ALERT SERVICE BULLETIN

No. 76A003

SUBJECT: ENGINE CONTROLS

NR drop in flight - Slow drift in the XPC anticipator (collective pitch signal)

Figure 1

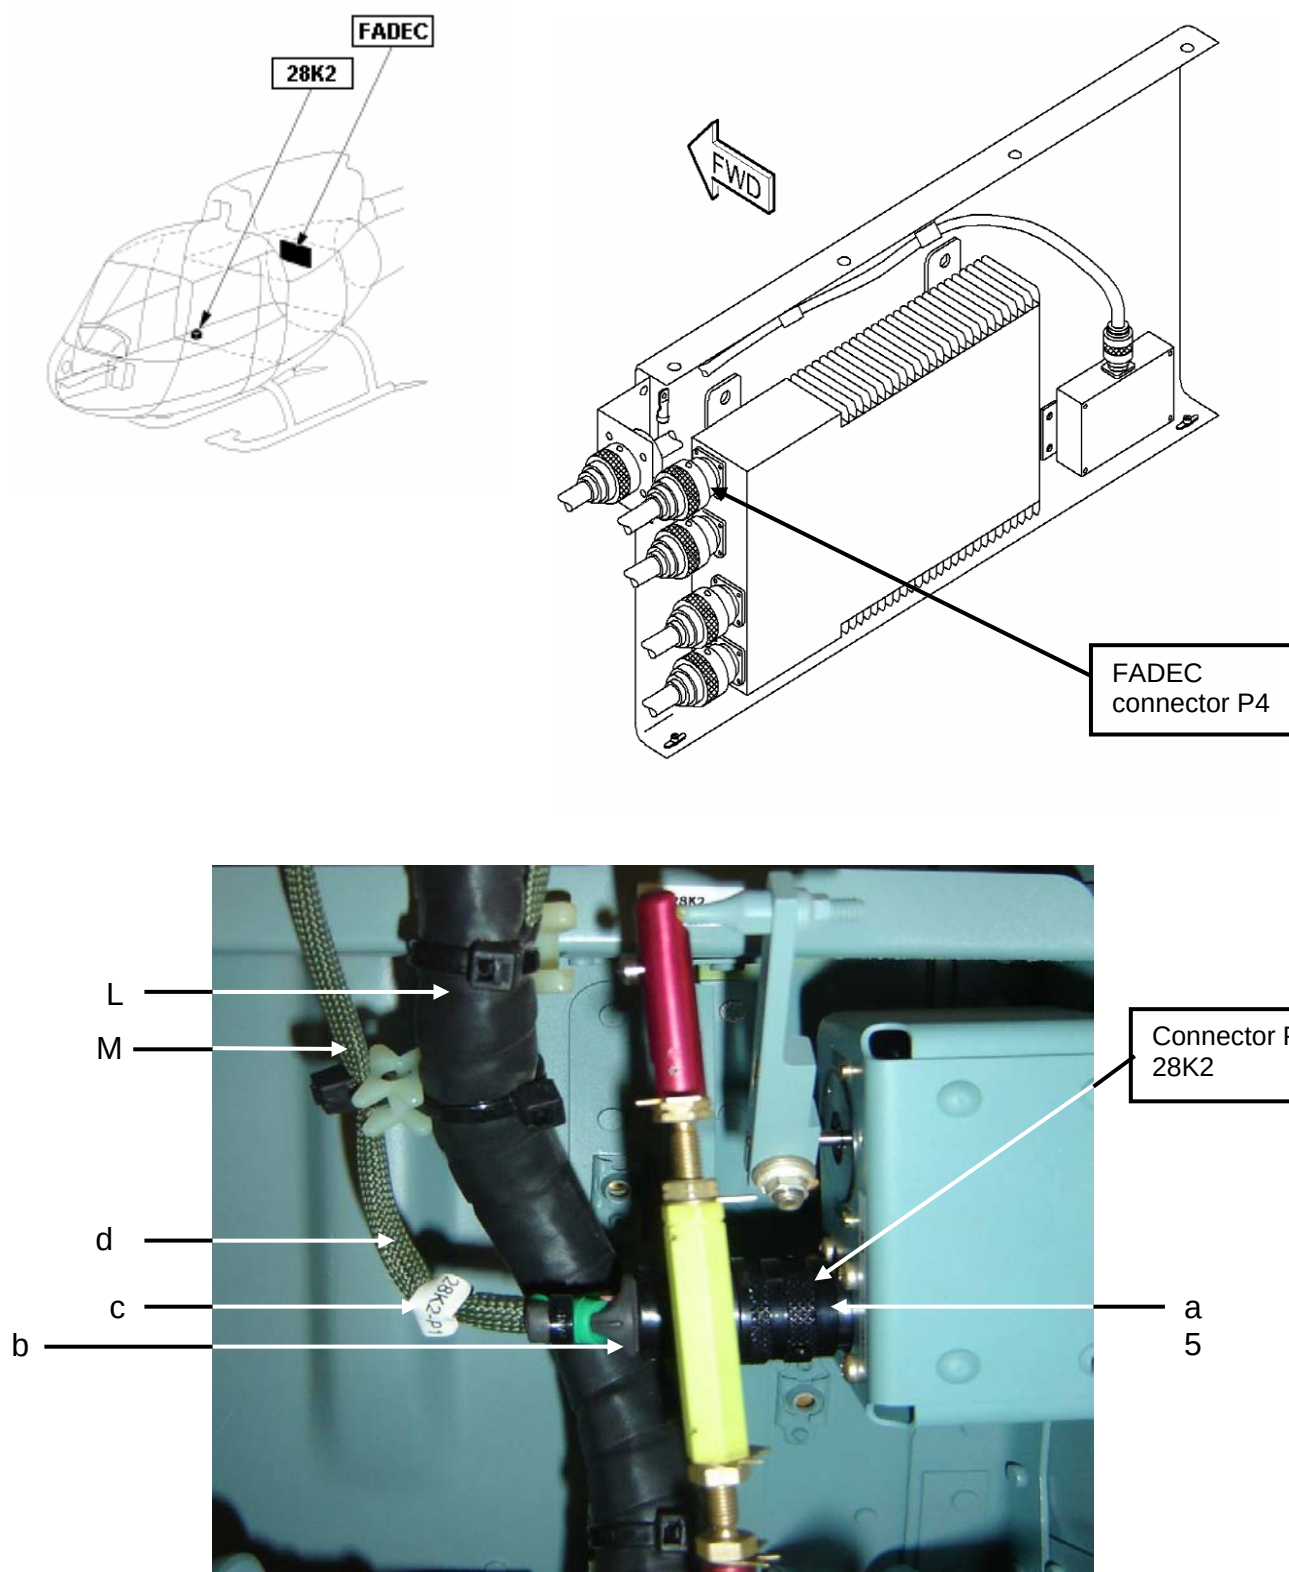
- Disconnect electrical connector P4 from the FADEC (Figure 1).
- Disconnect the electrical connector P1 from XPC anticipator (28K2) (Figure 1).
- In zone Z (Figure 2), cut and discard the binding clamps, then remove the spiral wrap tubing from electrical harness (L), in order to release the XPC cable over-length (M).

- Cut the XPC cable to eliminate any loops and potentially damaged areas.
- Unplug the contacts from the XPC connector.
- Retain connector (a), adapter (b) and marker sleeve (c) (Figure 1).

- Strip the conductors.
- Crimp contacts (5) to the conductors.
- Cover the cable with NOMEX sheath (d).
- Adjust the length of NOMEX sheath (d).
- Fit marker sleeve (c).
- Fit connector adapter (b).
- Insert contacts (5) into connector (a) in accordance with WDM 80-11-00.
- Tighten adapter (b) on connector (a).
- Conduct an electrical continuity test.
- Test the insulation between each of the three wires, then between each wire and the ground connection.
- Connect the electrical connector P1 of potentiometer XPC.
- Connect the electrical connector P4 on the FADEC side.
- Fit the spiral-wrap tubing that was removed previously, again round electrical harness (L).
- Secure electrical harness (L) with binding clamps.

Figure 2

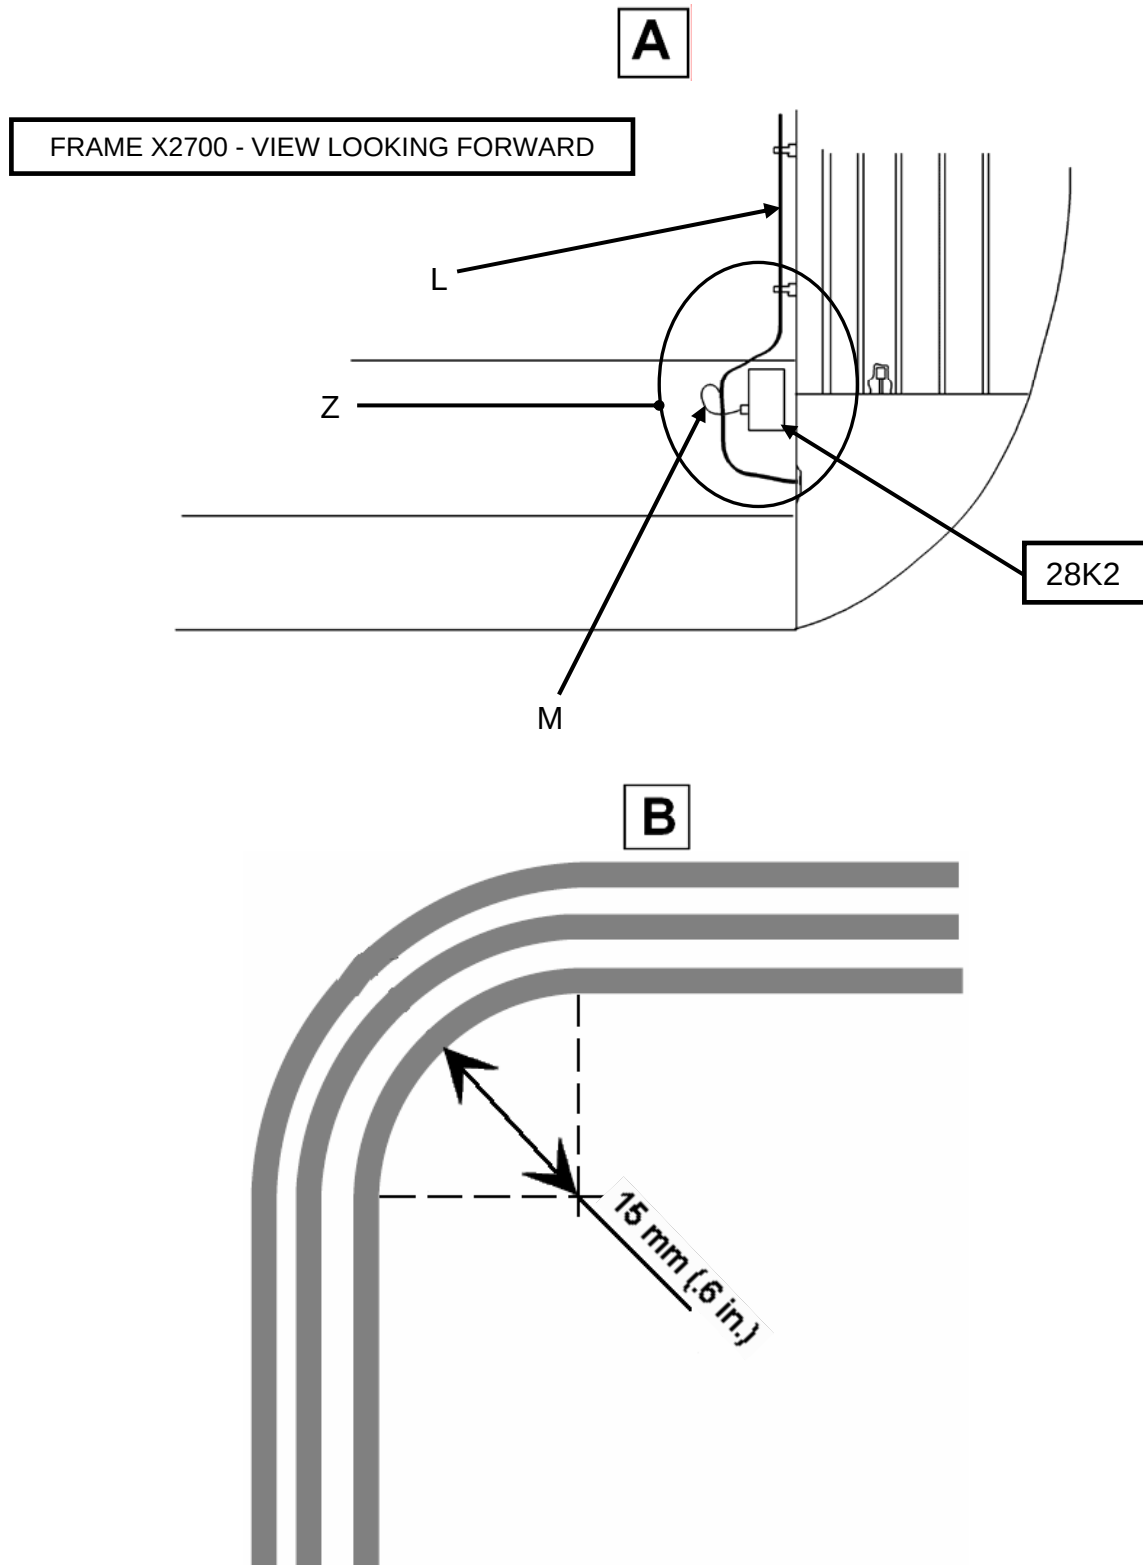
- Discard the previously cut cable.
- Check that the remaining length of the XPC cable (M) is sufficient to reconnect it to the XPC anticipator in accordance with the routing (Detail A) and curvature radius (Detail B), shown on Figure 2.

The adjusted cable length shall provide for a 15 mm (.6 in.) bending radiu: see Figure 2.

Figure 3

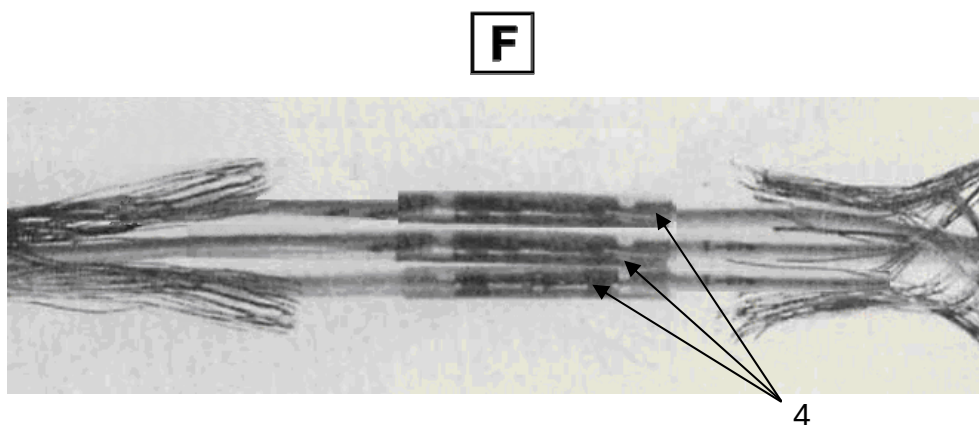
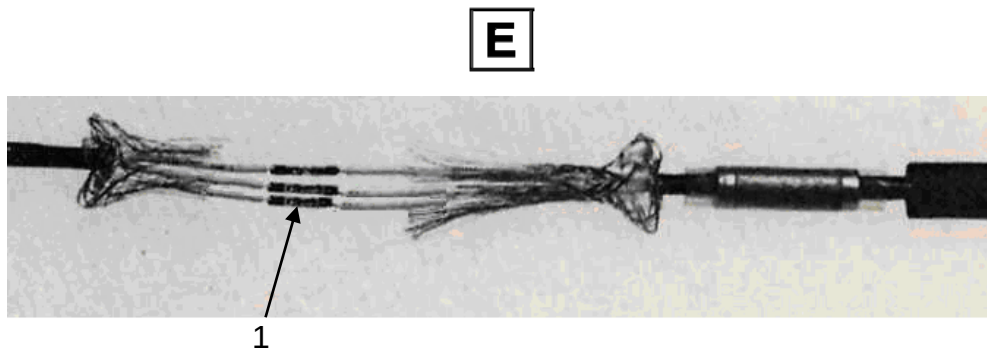
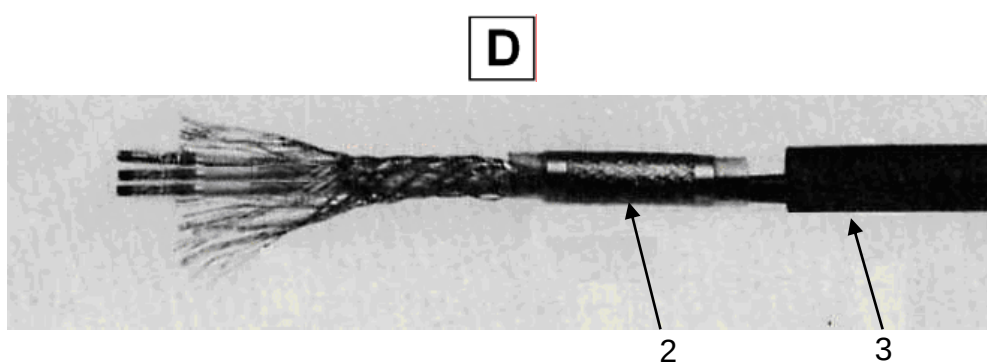
- Prepare a length of cable P/N E0274UD24 required to extend the existing cable.
- Prepare a length of NOMEX sheath required to extend the existing cable.
- Push back the NOMEX sheath on the existing cable.
- Strip the cables over a length of 60 mm to access the shielding.
- Position heat-sealing braid (2) and heat-shrinkable sleeve (3) on one of both cables (Detail D, Figure 3).
- Push back the cable shielding.
- Strip the conductors over a length of 6 mm.
- Crimp the extensions (1) on one end of the conductors (Detail C, Figure 3).
- Position the insulating sleeves (4) of the extensions on each conductor.
- Crimp the other end of the extensions (1) as shown on (Detail E, Figure 3) and in accordance with WDM 80-11-00.
- Position the insulating sleeves (4) on the extensions (1), (Detail F, Figure 3).
- Shrink the insulating sleeves (4) using a hot air generator.

Figure 4

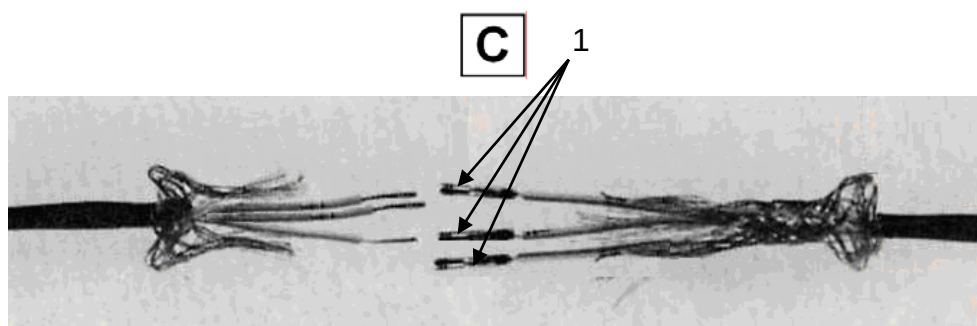
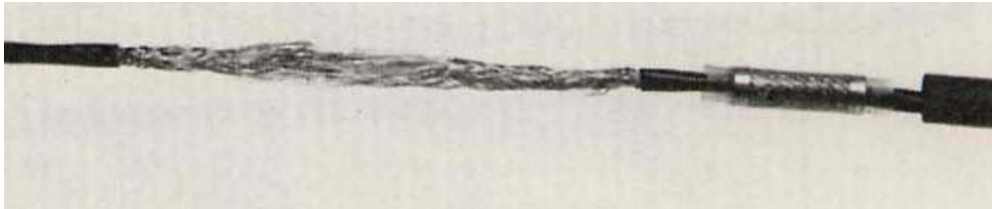
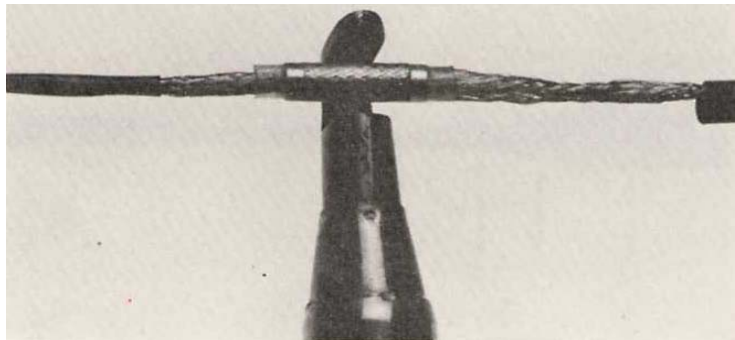
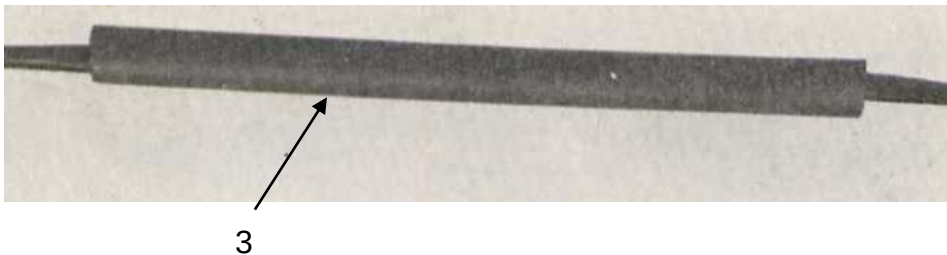
- Fit the cable shielding (Detail G, Figure 4).
- Fit the heat-sealing braid (2) (Detail H, Figure 4).
- Shrink the heat-sealing braid (2) with a hot air generator (Detail J, Figure 4).
- Position the heat-shrinkable sheath (3) on the splice, thus insulating it from the other wiring (Detail K, Figure 4).
- Shrink heat-shrinkable sheath (3) using a hot air generator.
- Push forward the NOMEX sheath.
- Insert a NOMEX sheath on the added piece of cable.
- Hold the NOMEX sheaths together with a binding clamp.
